TEXAS WATER COMMISSION
Comprehensive GW Monitoring Evaluation (CME) Report

TWC Reg. No. 31052

FACILITY NAME Denka Chemical Corporation

Technical Report
Comprehensive GW Monitoring Evaluation (CME)

BORING AND PIEZOMETER LOCATION PLAN
[As reported by Espey, Huston & Associates, Inc.,
December, 1982]

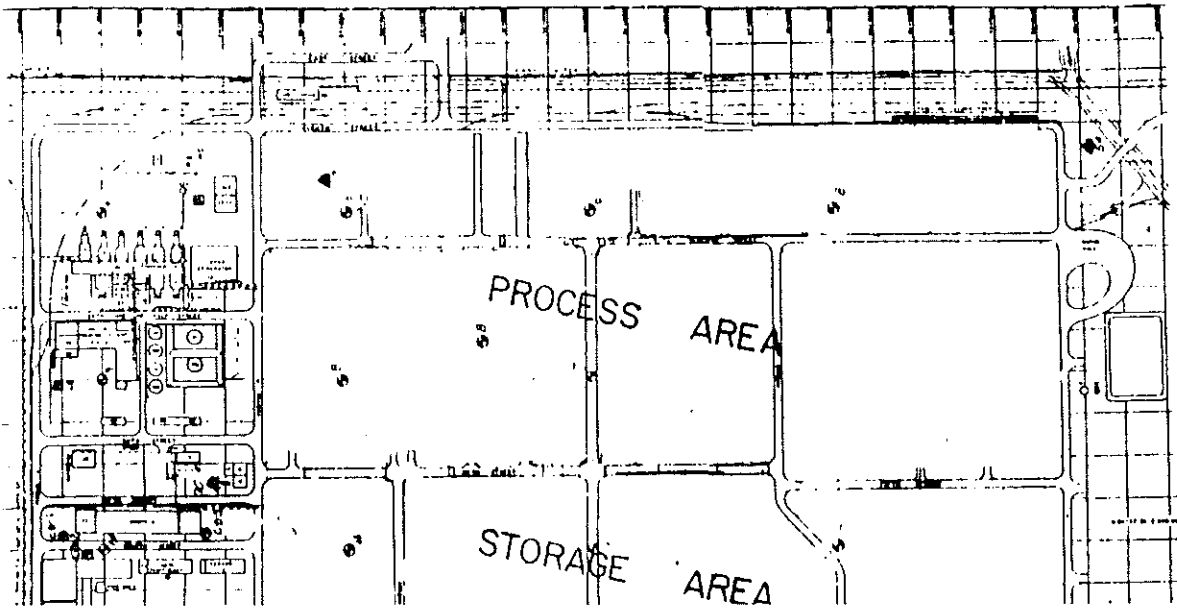
Comments: 5g continued: Additional downgradient wells are necessary for both HWM areas (HWM area No. 1 and HWM area No. 2 as designated on Attachment). The downgradient wells do not appear to be located so that all likely pathways of contaminant migration are monitored. Three downgradient wells is the minimum number of wells that can be installed at a HWM area, Denta does not have 3 downgradient wells. The wells should be placed immediately adjacent to the waste management areas, a number of Denta's wells are placed such that they will not allow Denta to immediately detect contaminant migration. The spacing between the downgradient wells is dependent on site subsurface conditions, however, usually the spacing between wells should be 150 ft or less. The spacing between Denta's downgradient wells is substantially greater than 150 ft.
